From: Booth-Binczik, Susan D (DEC) <Susan.Booth-Binczik@dec.ny.gov>
Sent: Friday, May 5, 2023 10:14 AM
To: Eric S. Rogge, P.E.; Michael A. Bodendorf, P.E.
Cc: Masi, Lisa M (DEC)
Subject: RE: Kimmel Subdivision - 325 Pine Ridge Dr, Wappinger

I looked over the submitted materials concerning a proposed 5-lot subdivision of a 13.6-acre property located at 325 Pine Ridge Drive in Wappinger. As indicated on the EAF, this project site is in an area occupied by Blanding's turtle and Indiana bat. Proposed projects at the site therefore need DEC Bureau of Wildlife review for potential impacts to these species and a determination on whether an incidental take permit is needed, pursuant to section 11-0535 of the Environmental Conservation Law.

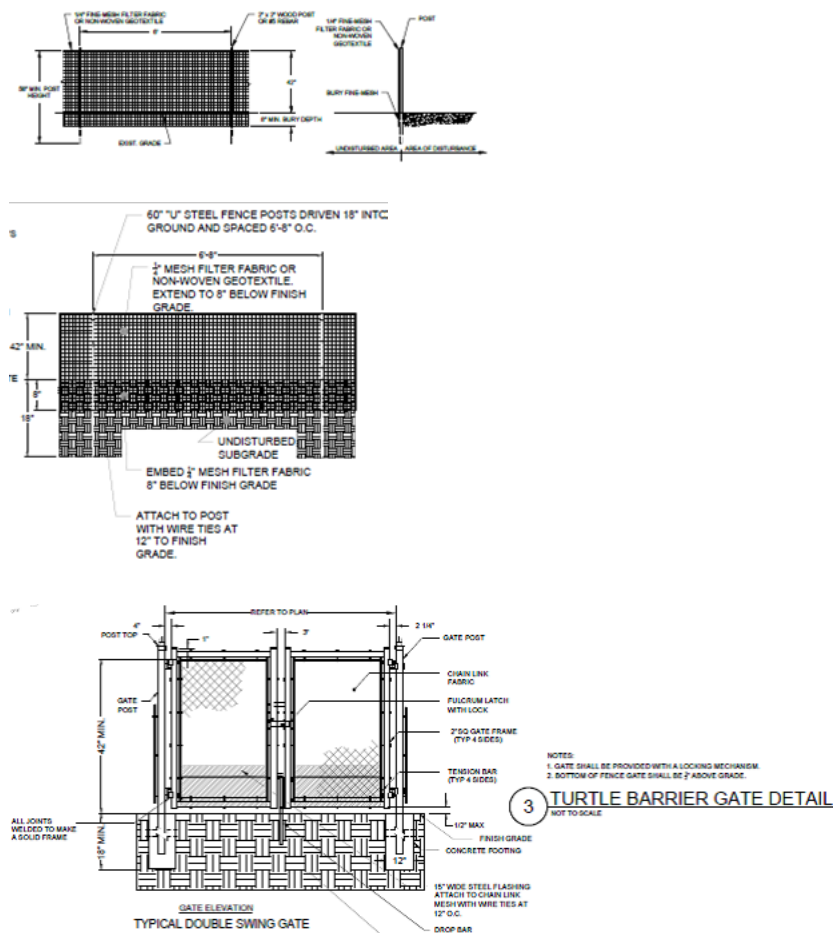
Hi Eric,
Below are a couple of examples of barrier and gate detail drawings. Some approaches that other projects have taken to make sure that turtles can't get under the gate are to attach some sort of sweep to the bottom or to put sandbags along the bottom of the gate when it's closed.

If barriers meet roads, there should also be curved turn-arounds at the corners where the fence meets the road, so turtles that might be walking along the fenceline would be turned back away from the road rather than directed into

it. The turn-arounds should have a radius of at least a few feet so the turn isn't too sharp and the turtles can navigate it easily.
